S-0031-2017,234 Neck O'Land Subdivision

Re: Minor Subdivision of 234 Neck-O-Land Road (Development Plans)

James City County plan S-0031-2017

STORMWATER & RESOURCE PROTECTION DIVISION REVIEW COMMENTS 234 Neck O'Land Subdivision COUNTY PLAN NO. S-031-17

01 of 12

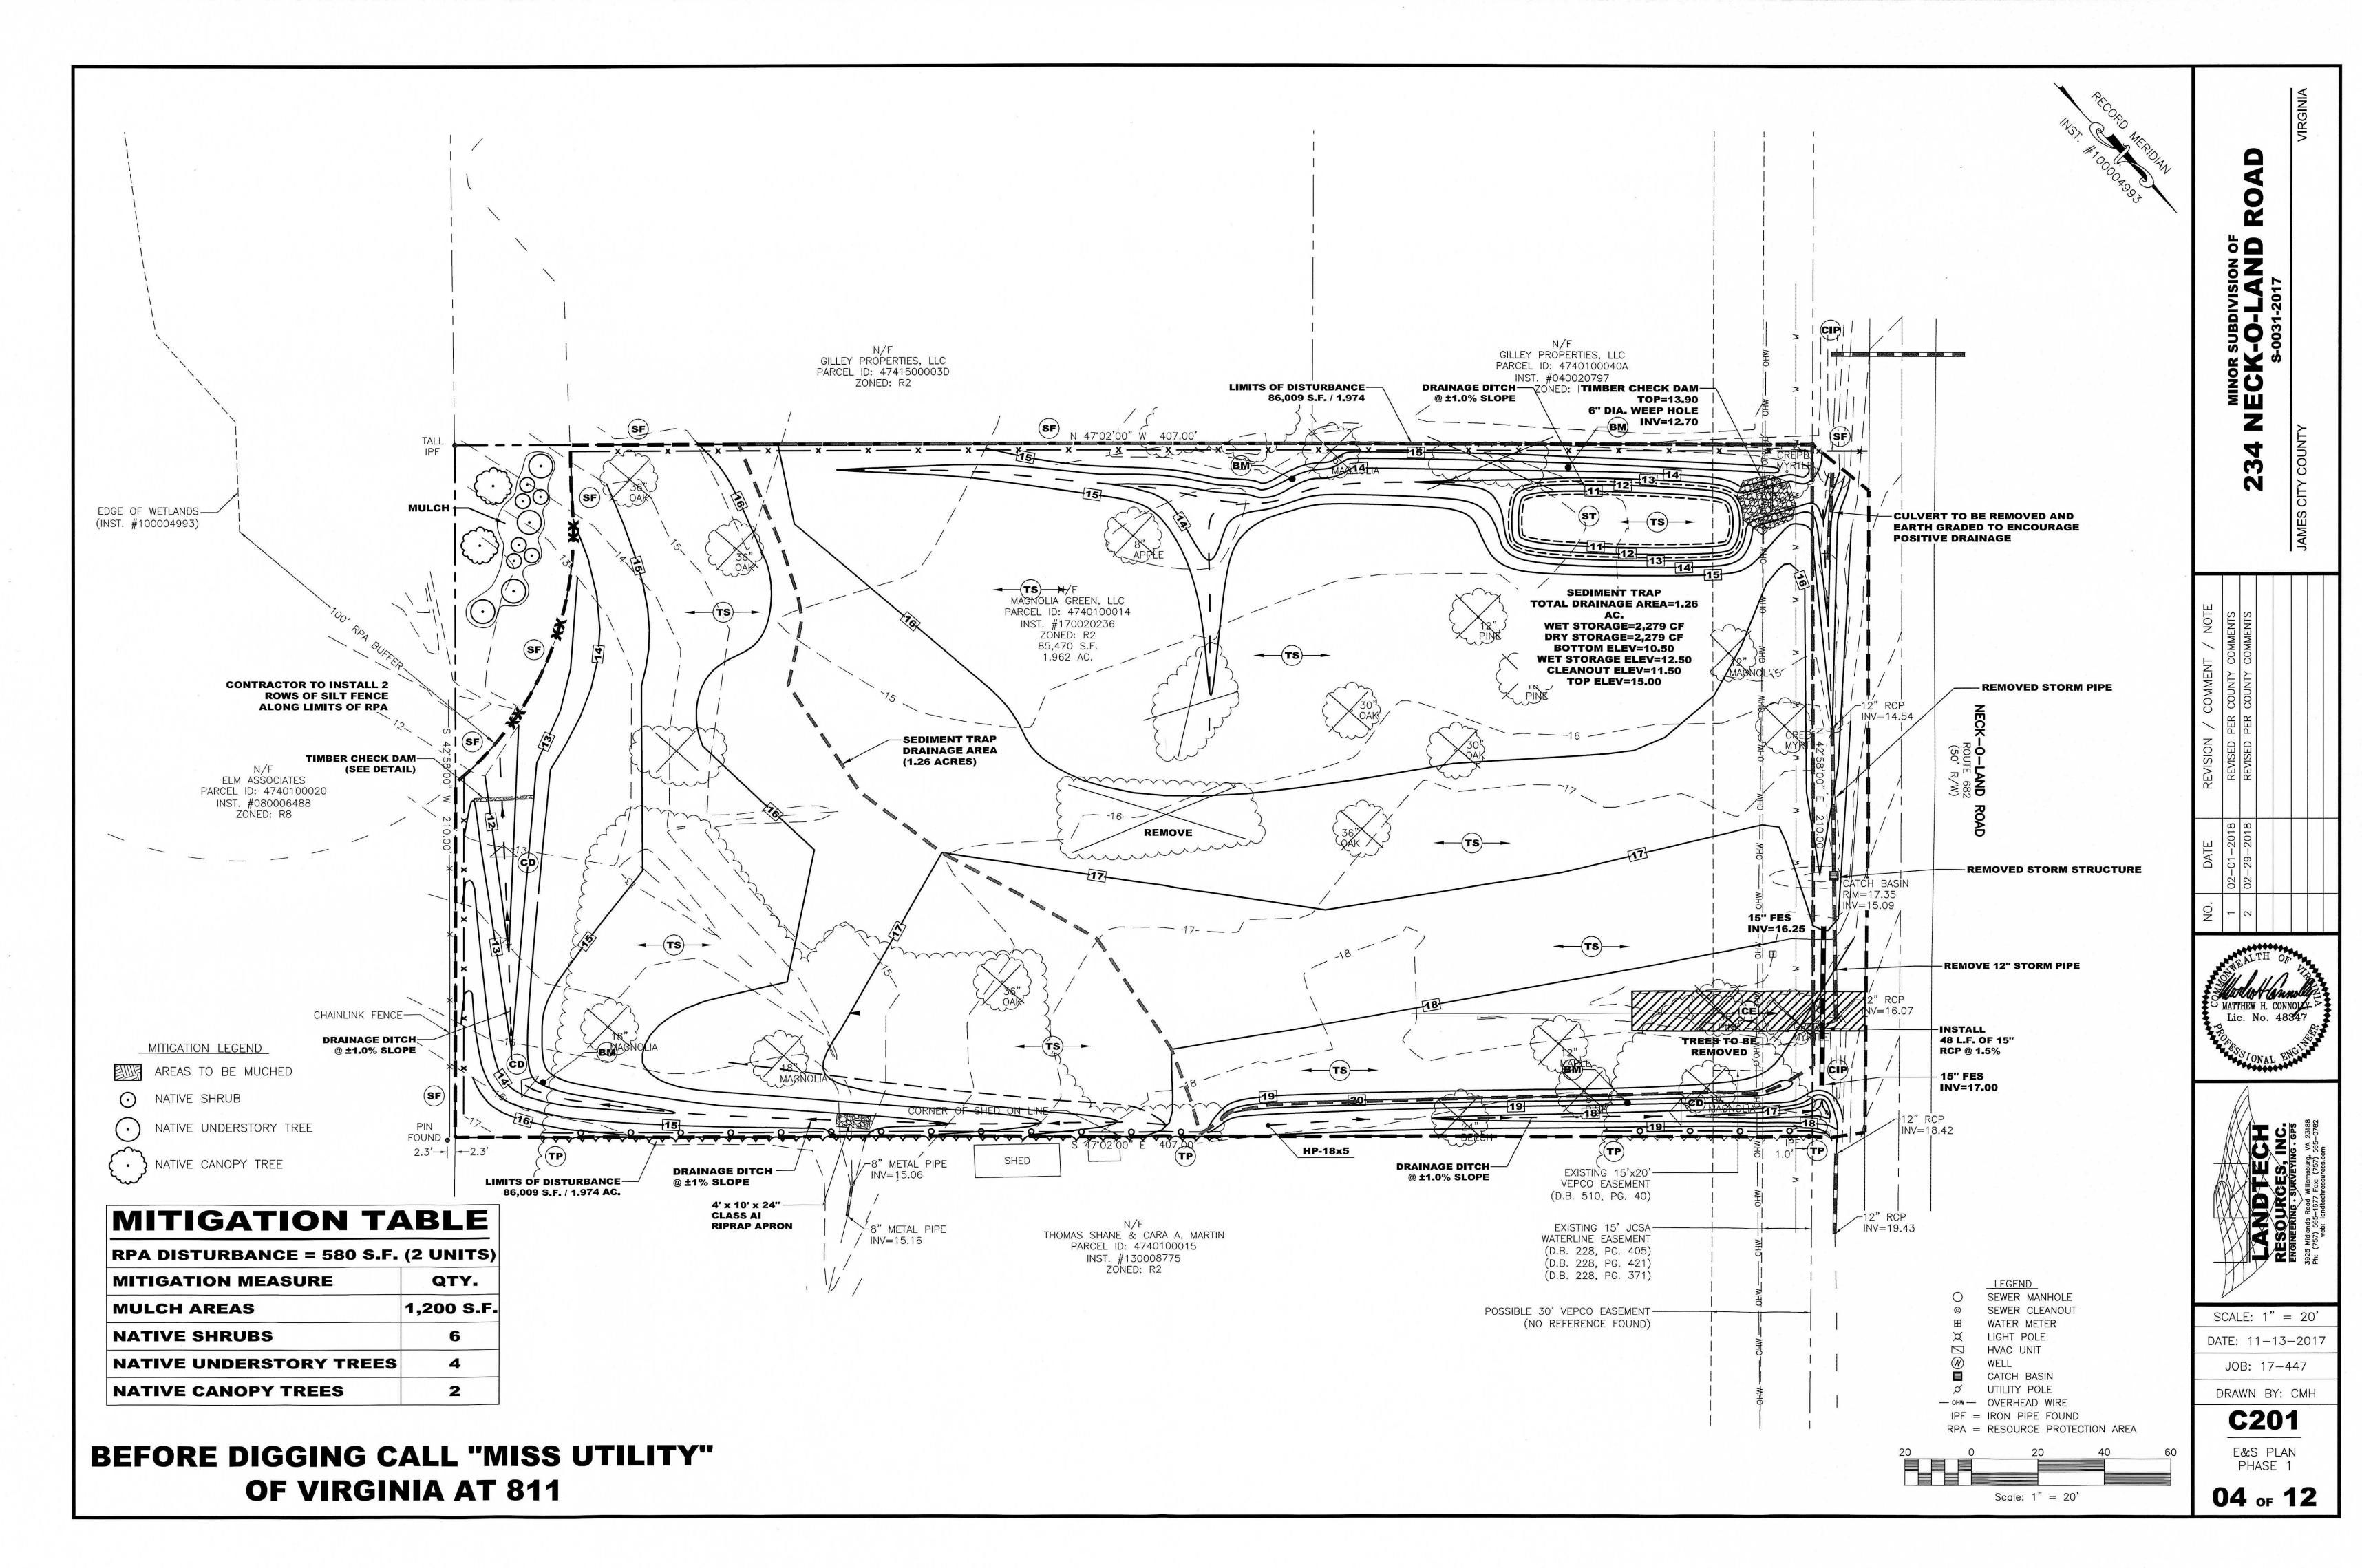
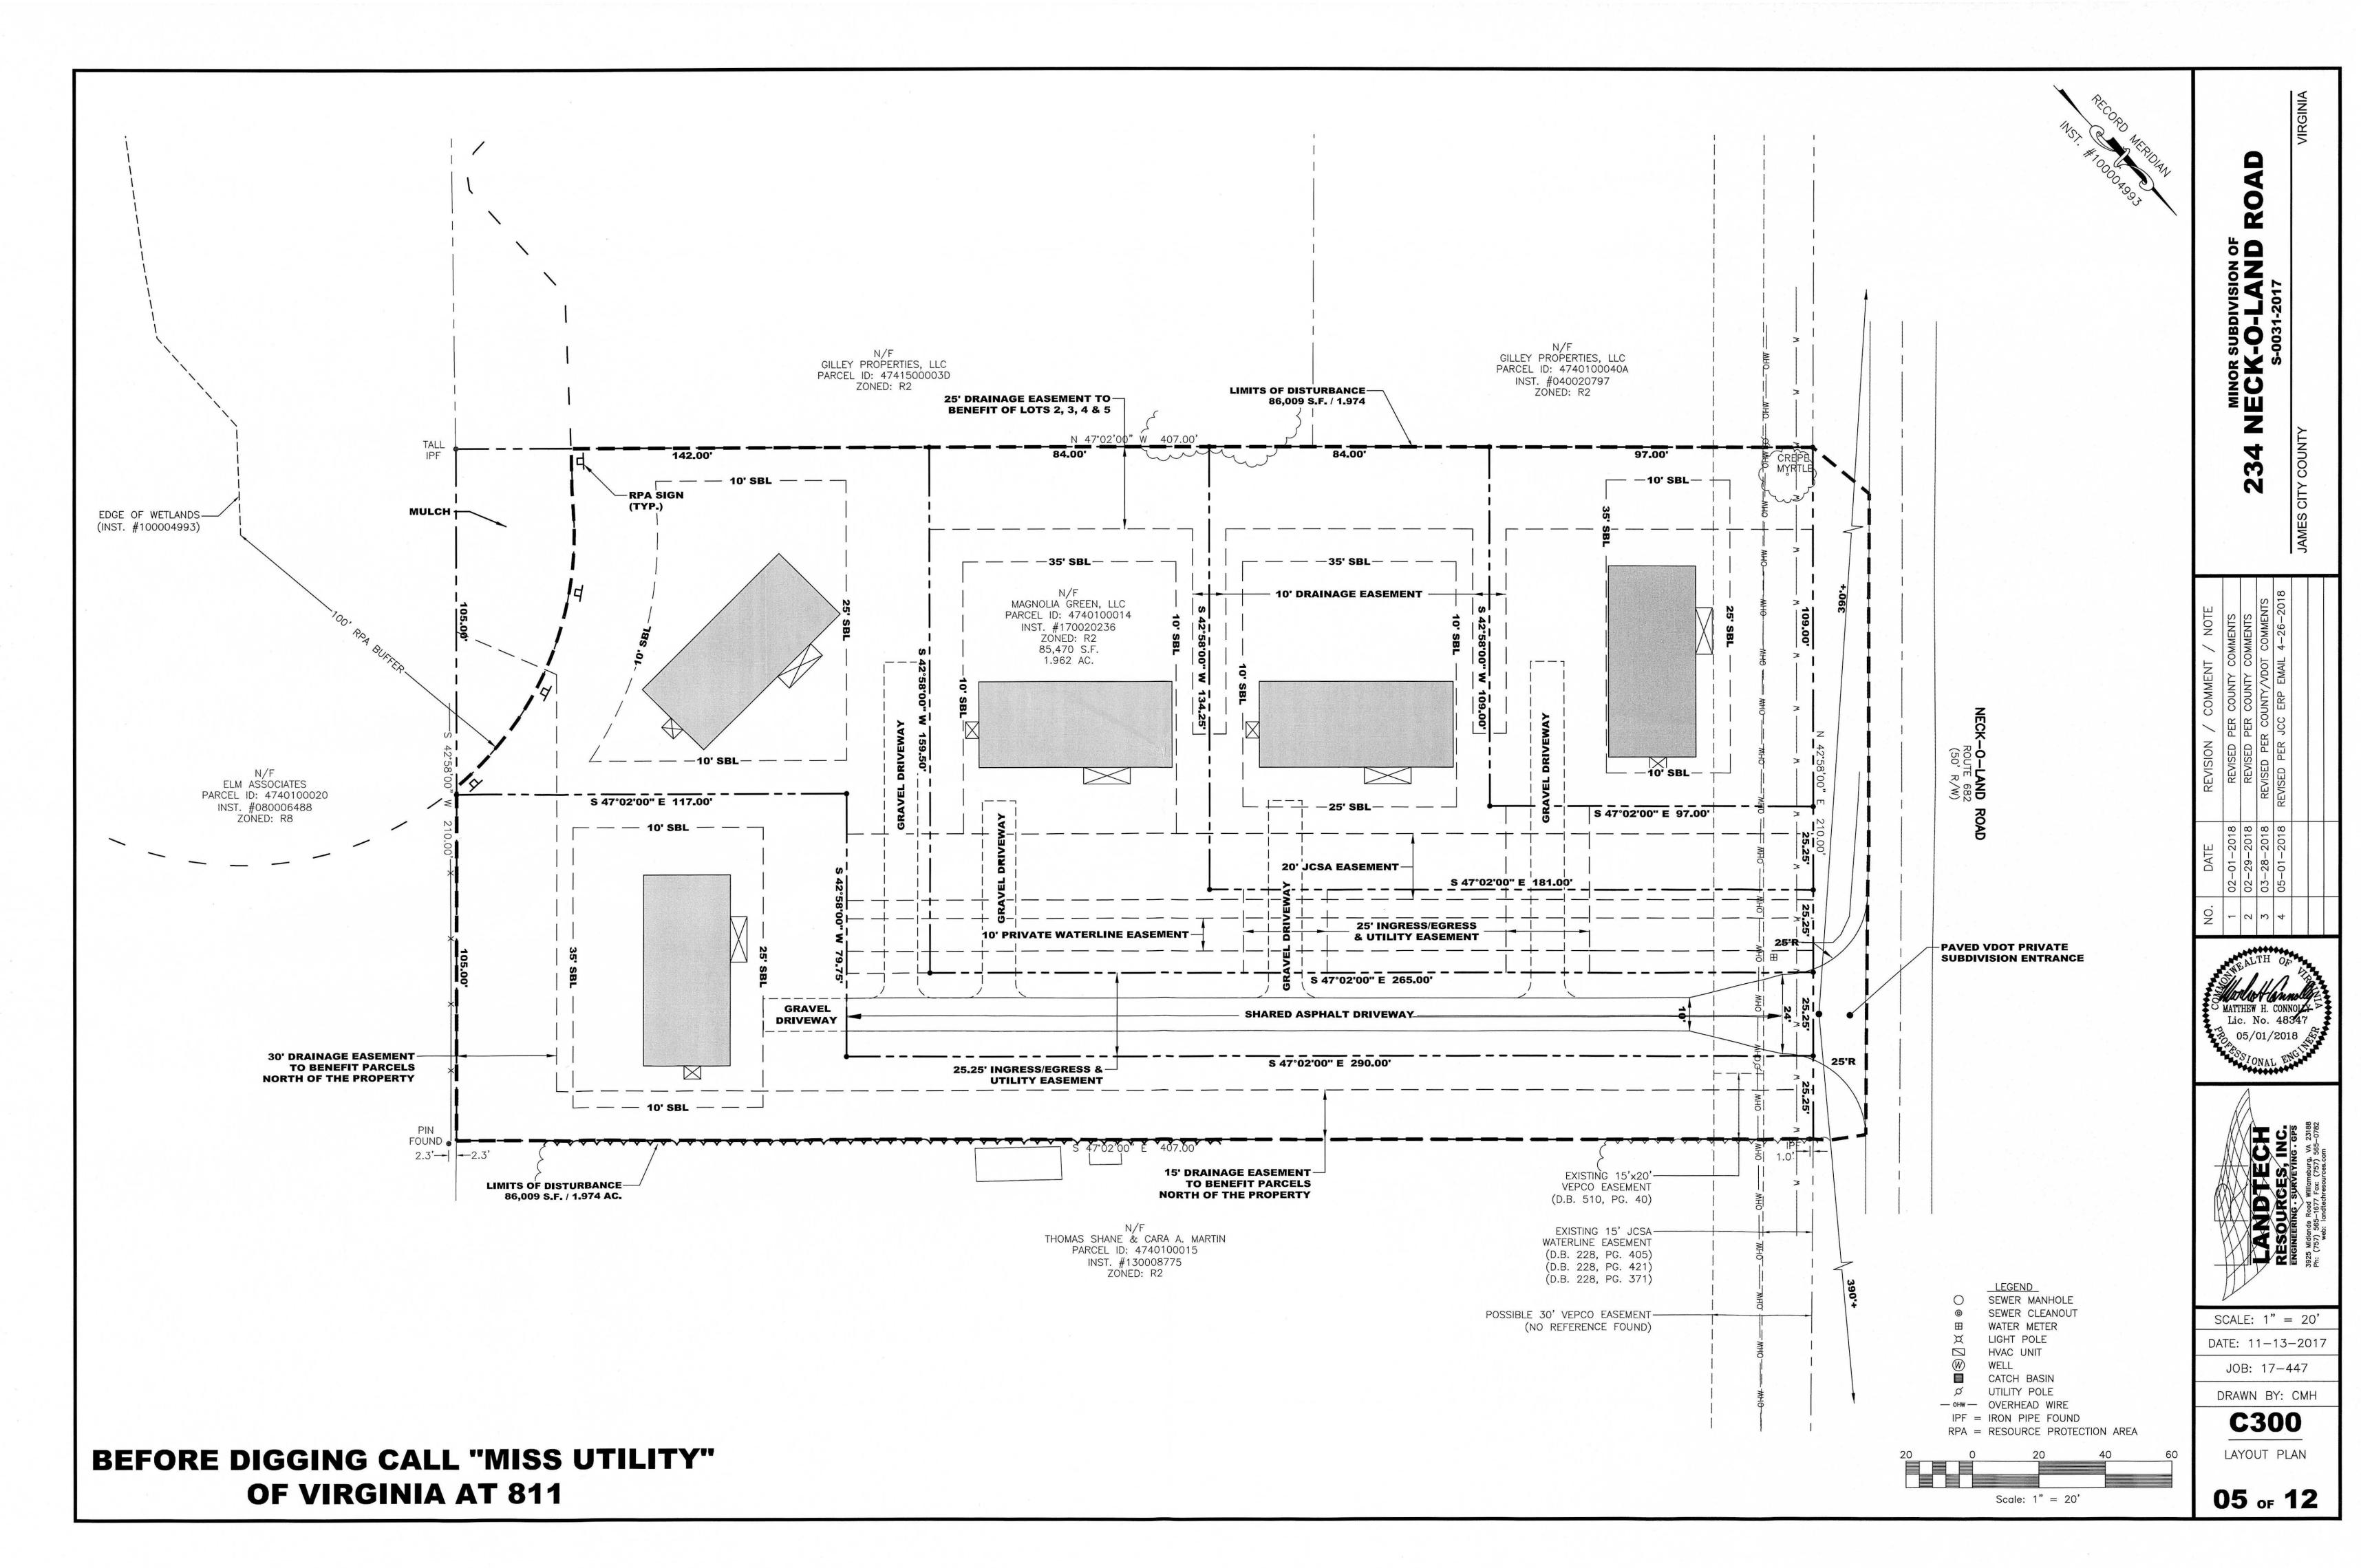
- 1. Sediment Trap. The proposed sediment trap needs to be installed at the Phase I as part of the preliminary E&S Control measures. Review.
- 2. Proposed Ditches. The proposed ditches not in connection with the sediment trap should have a riprap and stone barrier similar to the one in the trap spillway to control sediment laden from leaving the site. Consider isolating the ditch that runs toward the RPA entirely, since offsite runoff will be also added to it.

- 5. Proposed Ditches. The temporary check dams shown on sheet C400 should be installed on the Phase I of the Erosion and Sediment Control plan. Ensure this is included on the construction sequence as well. Please review.

1. A sediment trap has been added to C201

- 2. Swales have been relocated to run along the property lines. Easements have been added over top of drainage swales.
- 3. The level spreader is not designed in accordance with VA DEQ Stormwater Design Spec #2. The intent is just to spread out concentrated flows.
- 4. This area has been revised.
- 5. An easement have been provided on the diversion swales along the edge of the property to benefit the northern parcels.
- 6. Two (2) sets of calculations have been included with this submission showing compliance.
- 7. Water Quantity Drainage Maps with appropriate calculations have been provided at the end of the plan set.
- 8. Sections of the open channels have been provided on DA101
